To: T10 Technical Committee
From: Rob Elliott, HP (elliott@hp.com)
Date: 14 October 2003
Subject: 03-351r0 SAM-3 SPC-3 Extended Task Attributes mode page

Figure 1 — Asymmetric logical unit access

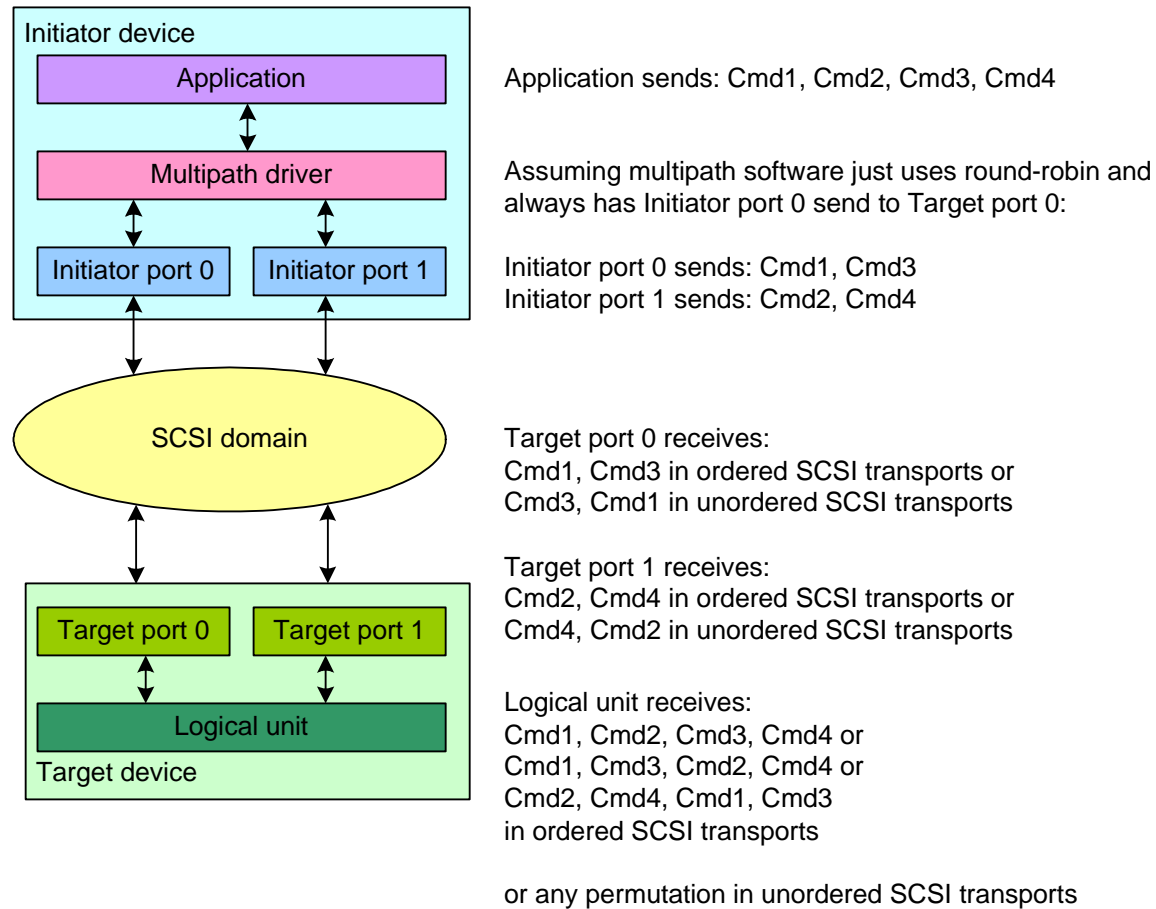
1. There is no way for an application client to tell which task attributes are supported. Some logical units may prefer not to support ORDERED, for example. This proposal lets software read a mode page to determine which task attributes are supported.
2. When asymmetric logical unit access is used (the SET/REPORT TARGET PORT GROUPS commands), applications can access a logical unit through more than one target port. There is no ordering relationship guaranteed between the I_T nexuses to the different target ports, even if the I represents the same initiator port. Multipathing software typically sits below the application in the initiator device, choosing which initiator port to use and which target port to address (i.e., choosing the I_T nexus). If the application tries to use

ORDERED tags, there is no good way for the multipathing software to preserve ordering across separate I_T nexuses. The commands may arrive at the logical unit in a different order than the application intended.

This proposal lets multipathing software disable support for ORDERED tags via the mode page so the higher-level application knows not to use them. It could either write to the mode page and disable the ORDERED tag, or it could intercept and modify reads to the mode page and make it appear that the ORDERED tag is disabled.
